POWER AUTHORITY OF THE STATE OF NEW YORK
10 COLUMBUS CIRCLE, NEW YORK, N.Y. 10019

CONSOLIDATED EDISON COMPANY OF NEW YORK, INC.
4 IRVING PLACE, NEW YORK, N.Y. 10003

In response to your September 15, 1982 letter, enclosed are our initial comments on the preliminary draft Letter Report on Review and Evaluation of the Indian Point Probabilistic Safety Study, Sandia National Laboratories, August 25, 1982 ("Sandia Report"). The following issues are addressed:

RESPONSE TO SANDIA LETTER REPORT
OF SEPTEMBER 1, 1982 ON THE
INDIAN POINT PROBABILISTIC SAFETY STUDY

FIGURE 1 (page 1 of 2)

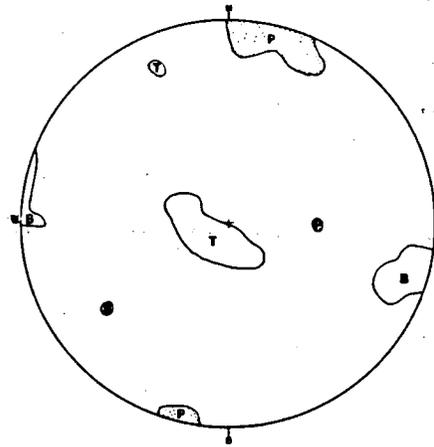
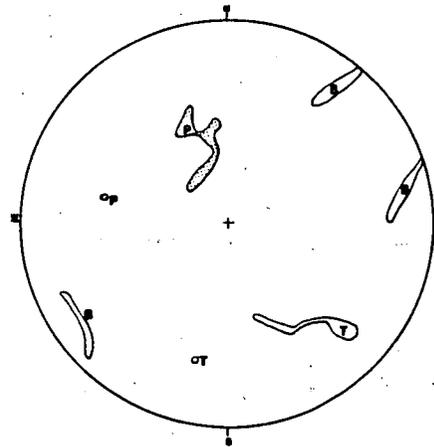
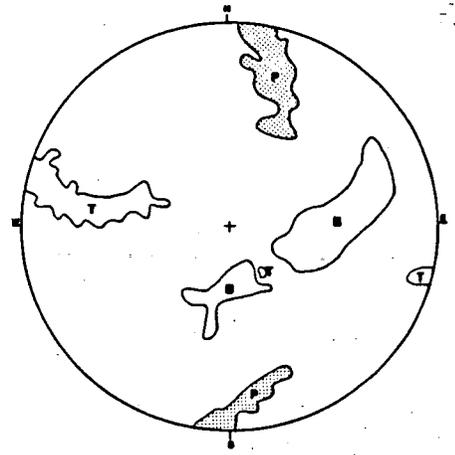
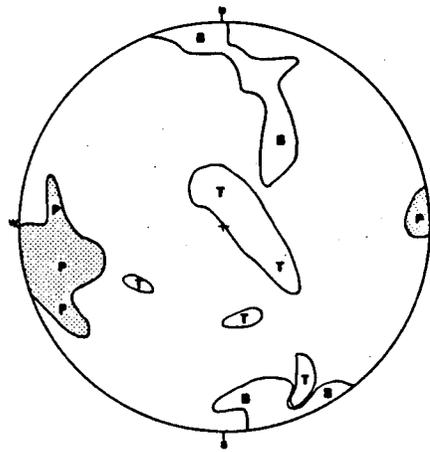
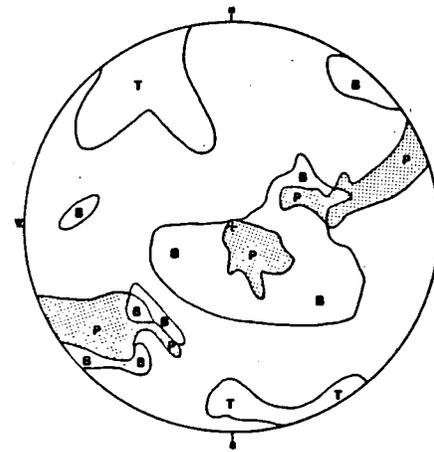
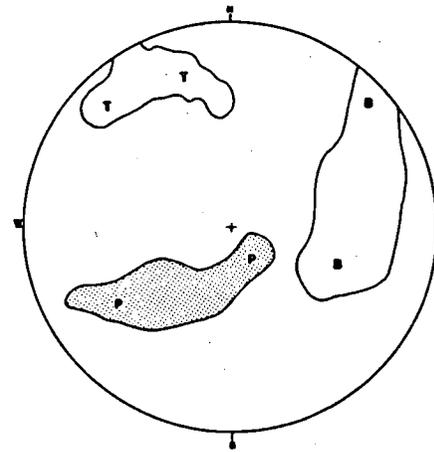
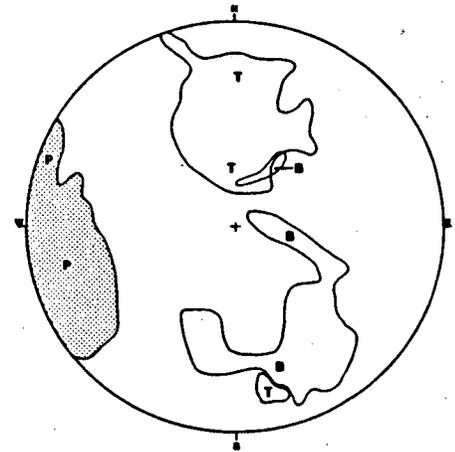
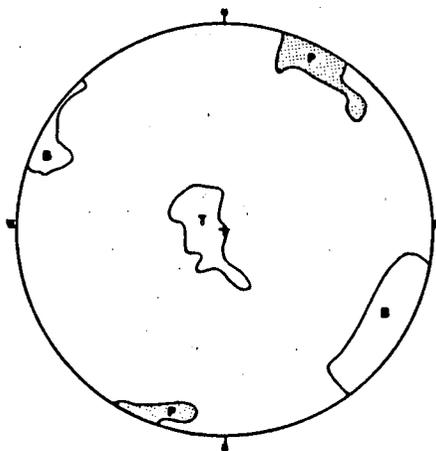
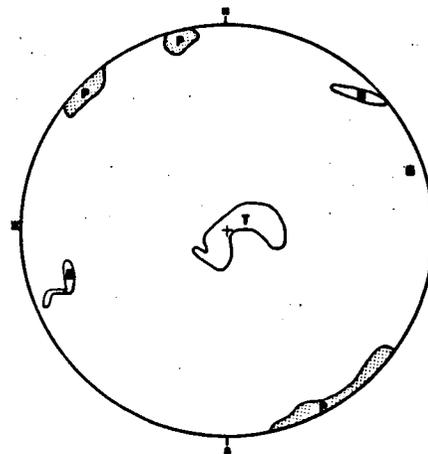
References 2 and 4 present fault plane solutions for the region about the Ramapo showing thrust faulting along planes trending northeast. These solutions are used to propose a southeast/northwest direction of maximum compressional stress for the region, as well as to postulate the reactivation of northeast trending structures in response to the applied regional stress. The proposed reactivation of northeast trending structures is directed specifically toward the Ramapo Fault as well as other major northeast trending structures.

Based on results presented in Figure 1, there appears to be good agreement between the majority of available local earthquake data and the direction of regional maximum compressive stress inferred from other data. Indeed, the composite data set suggests a reasonably uniform style of fault movement for microearthquakes within the region. This movement is consistent with northeast compressive stress.

The presence of northeast compressive stress is inconsistent with thrust type movements on the northeast trending Ramapo Fault zone or other subparallel structure. On the contrary, expected motions produced by northeast compressive stress are similar to the motions inferred for earthquakes such as the Wappingers Falls sequence, several earthquakes near Annsville, the Rockland Lake earthquake, the Suffern-Tuxedo Park earthquake, and the Thornwood earthquake. Further work may reveal other examples of this type.

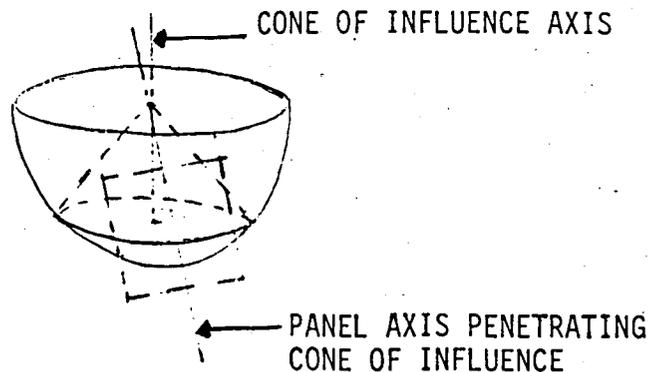
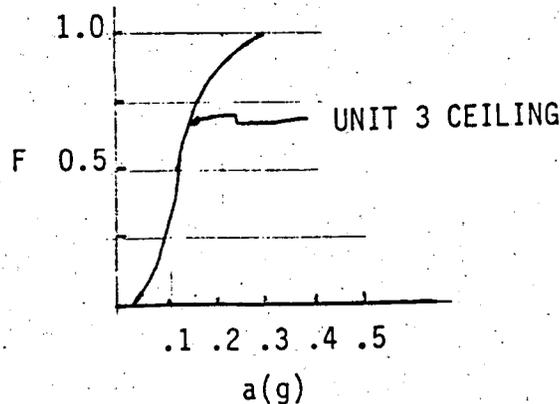
It was indicated by the reviewers that the seismic analysis did not consider the failure of the ceiling in the control room when assigning a fragility to the control building. The seismic analysis did consider the control room ceiling. It was judged that falling panels might result in injury to some personnel in the control room, but certainly not incapacitate all the operators or result in a loss of equipment functions in the room. In view of the review comment, we have investigated the Unit 3 ceiling fragility and the effects of its possible failure (see Appendix 1). Using the median seismic hazard curve and median fragility curve for the control room ceiling, the analysis concludes that, considering the requirement to incapacitate all operators in the control

Given failure of ceiling panels (as per seismic hazard and fragility information):

1. Probability of top panel failure causing falling of eggcrate and top panels = 0.8.
2. Probability of transite or eggcrate panel falling with a damaging edge intersecting a horizontal plane:
 - a. Surface of hemisphere = $2\pi r^2$.
 - b. Surface of segment = $2\pi rh$.
 - c. For right cone, $h = r - 0.707 = 0.293r$.

Calculation of core melt frequency (using composite fragility curve and median seismic hazard curve):
